City of Ferndale
Addendum 1

ADDENDUM NO. 1
To the Contract Provisions for
CITY OF FERNDAL, WASHINGTON

GATEWAY NORTH STORMWATER PROJECT
CITY PROJECT NUMBER SW2015-03

SHEET 9 of 11

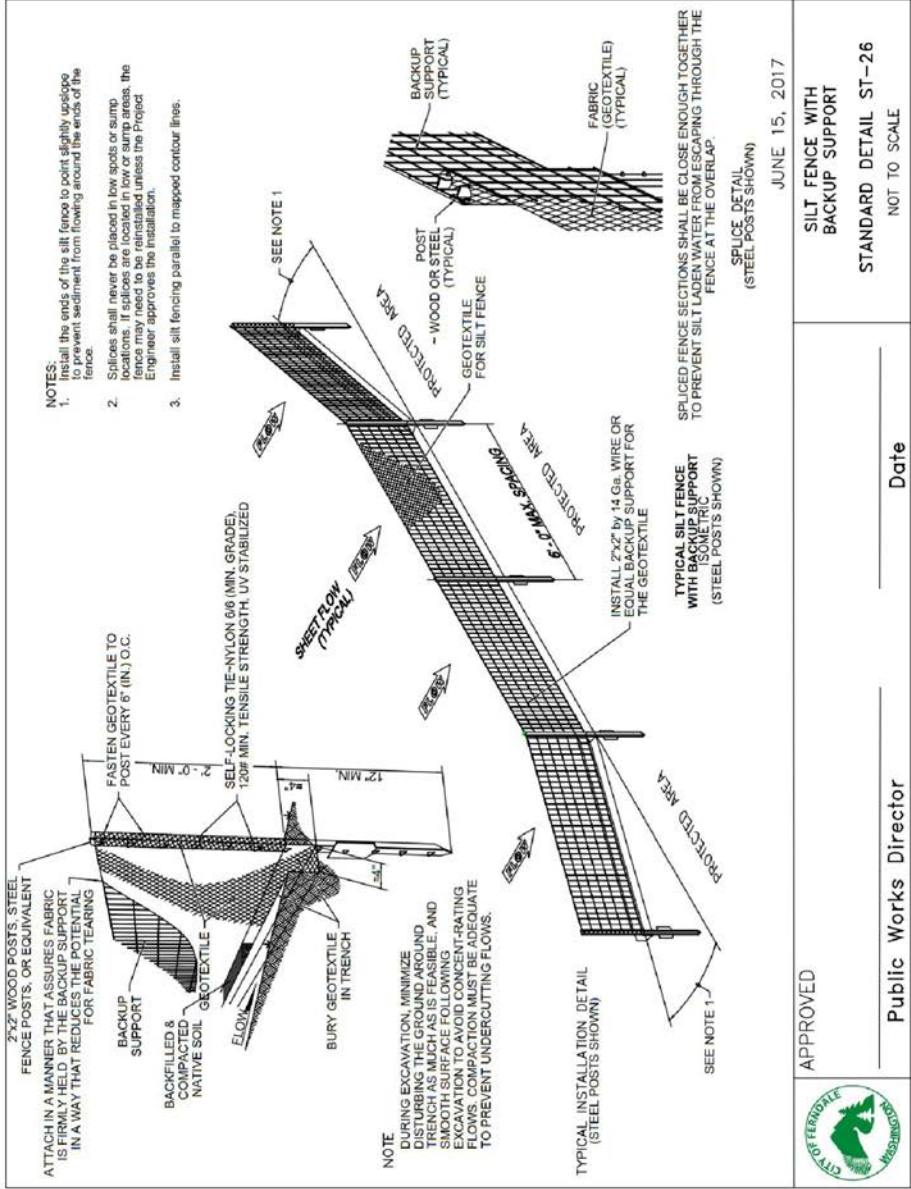
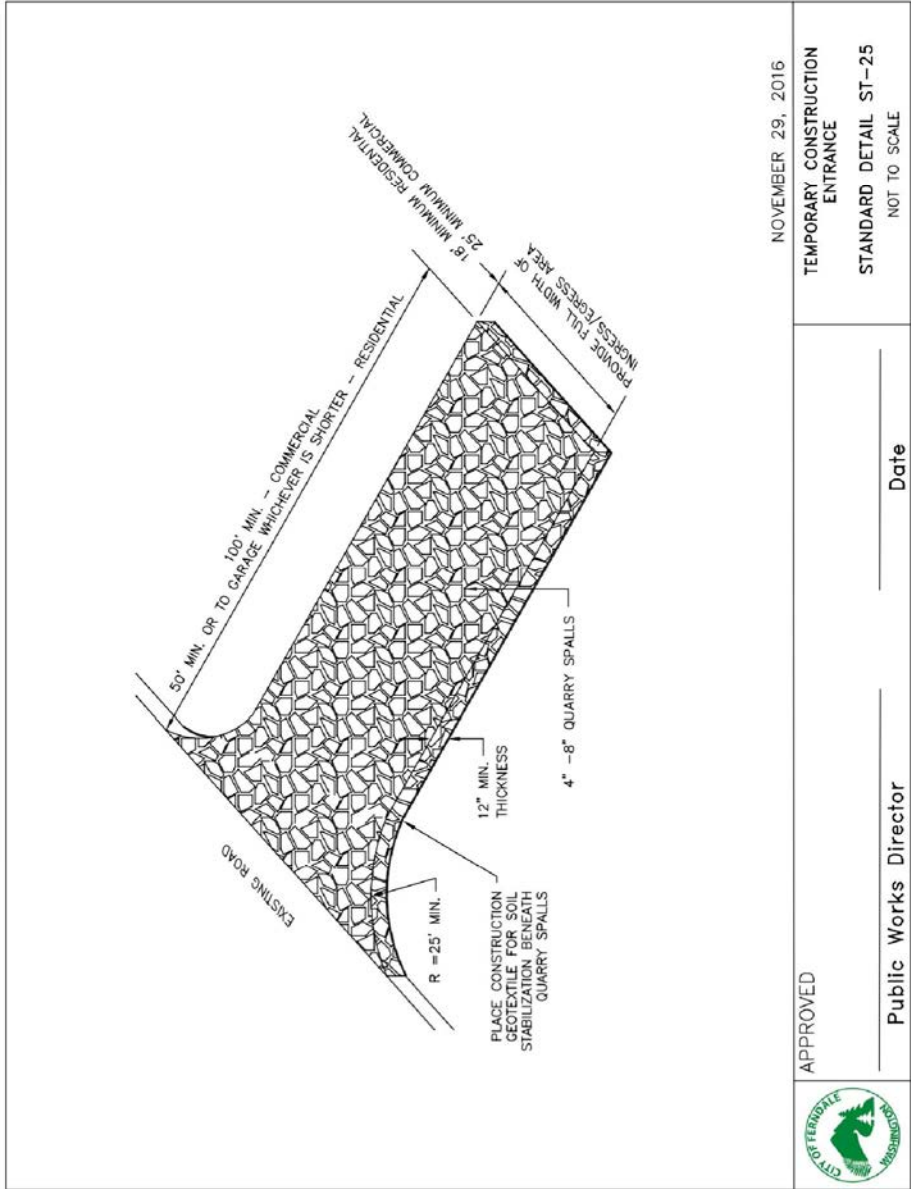
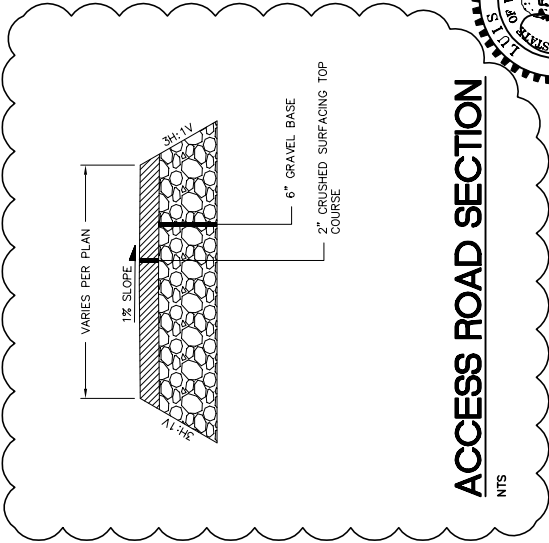
Plan Sheet 9

- The geotextile leader on the “Road Section At Wetland Crossing” was deleted and the dark line between the gravel base and quarry spalls was removed to prevent confusion.
- “Access Road Section” was modified as shown.

OUTFALL ANCHOR DETAIL

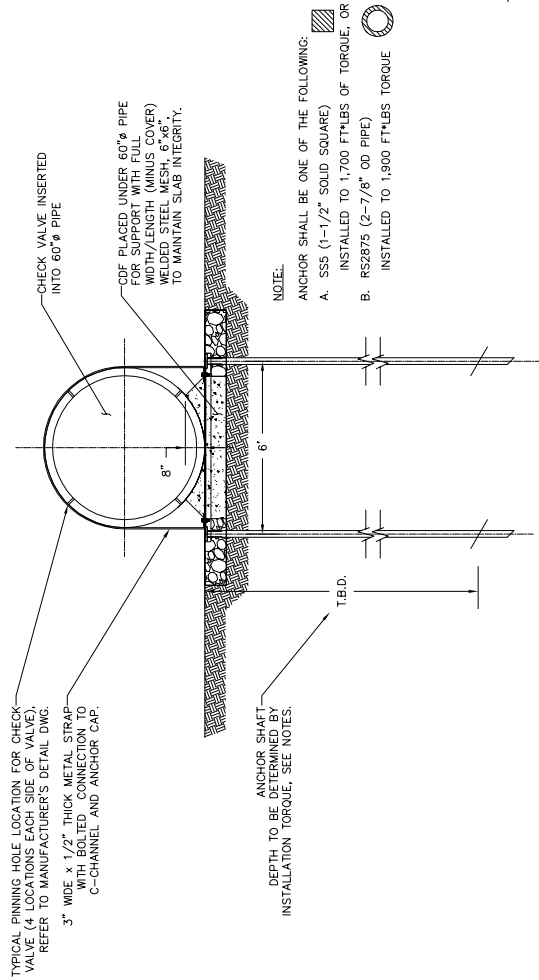
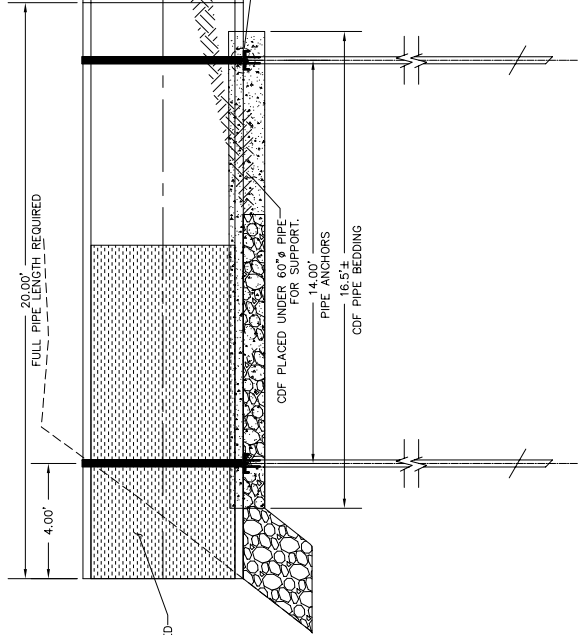
Plan Sheet 11

- “Outfall Anchor Detail” was added.
